SCHEMATIC FOR INTERMODULATION ANALYZER

IM-1

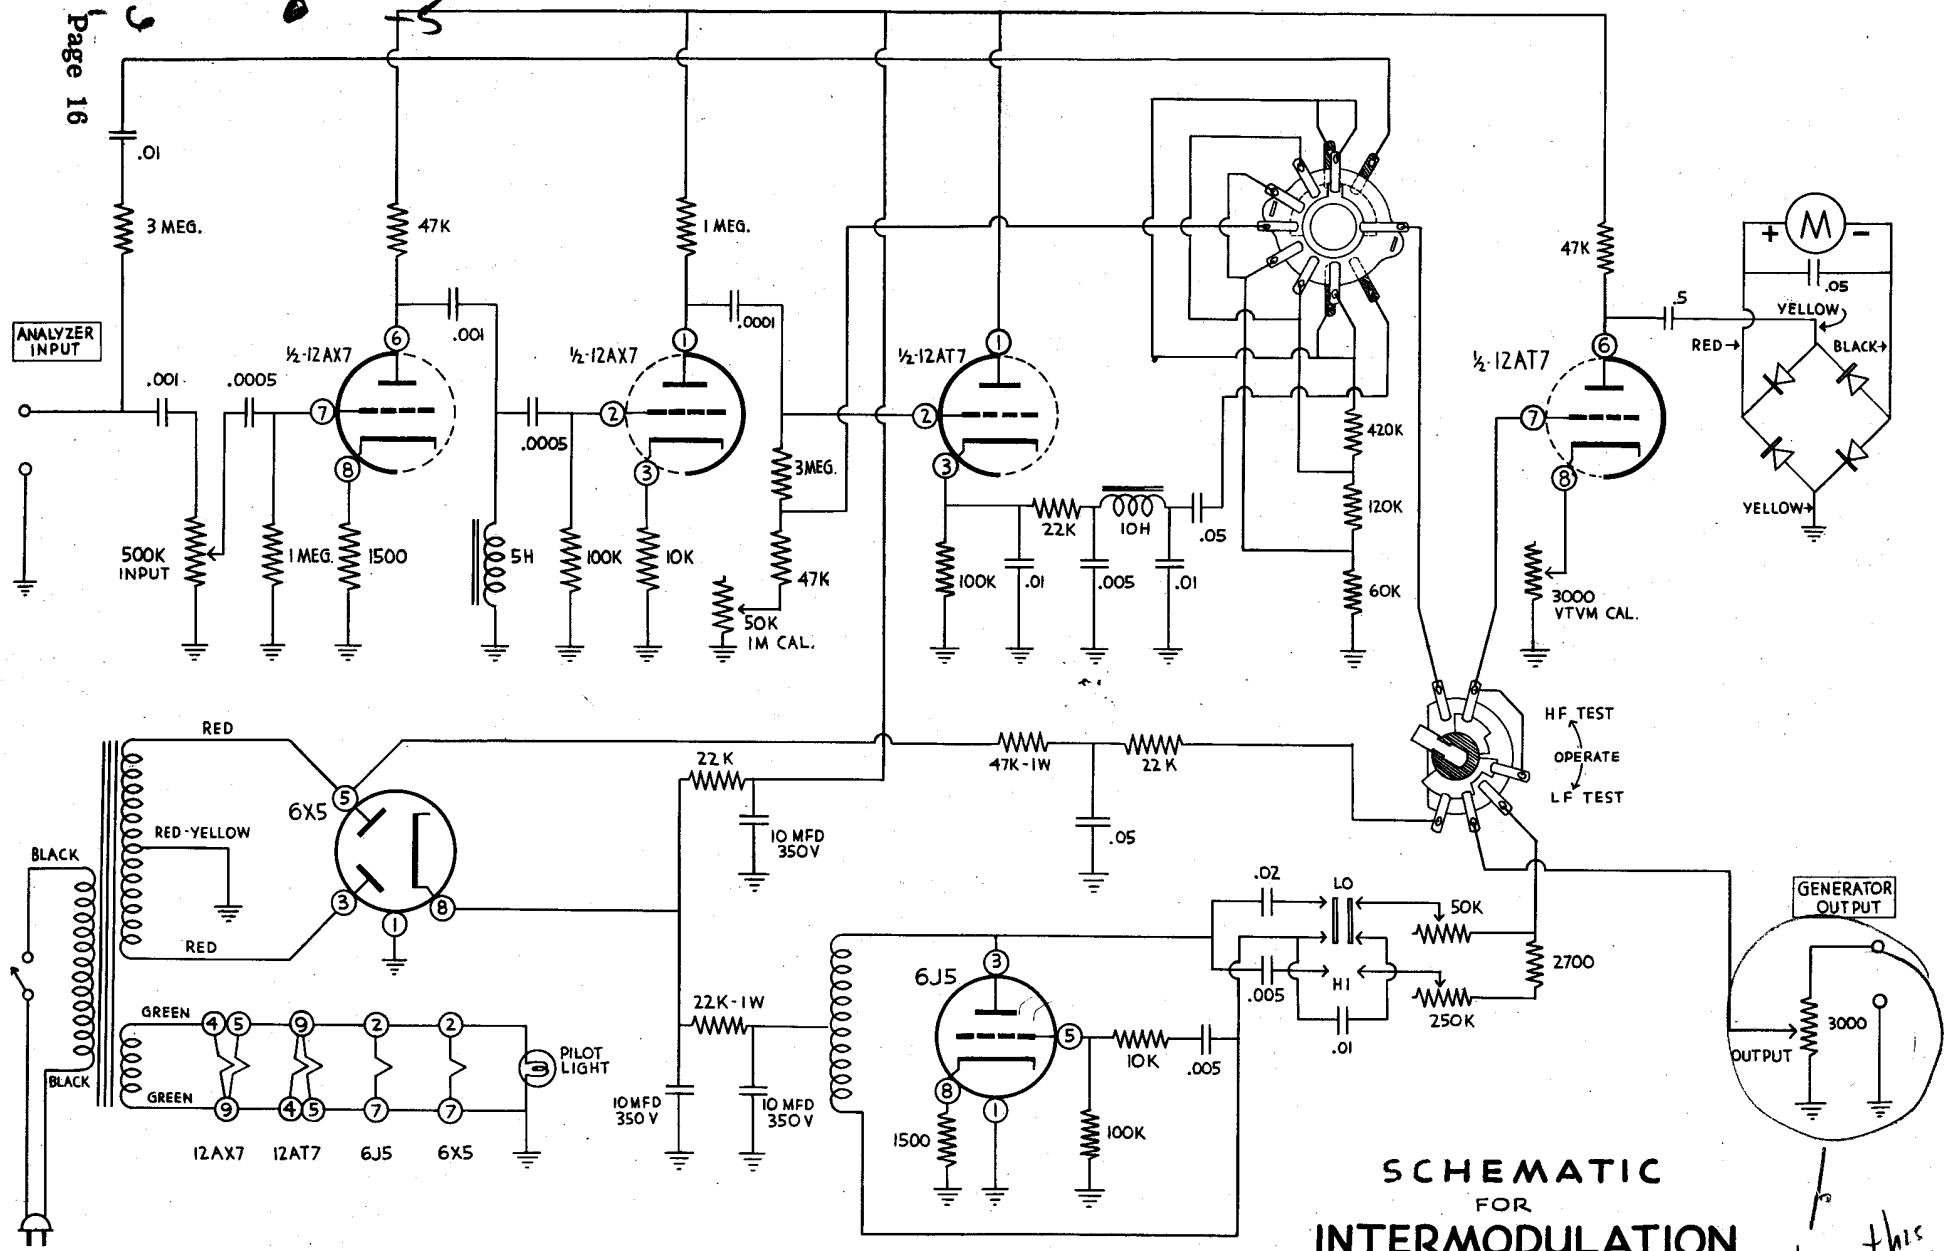
has this been shunted w/ a 750Ω res for 600Ω output
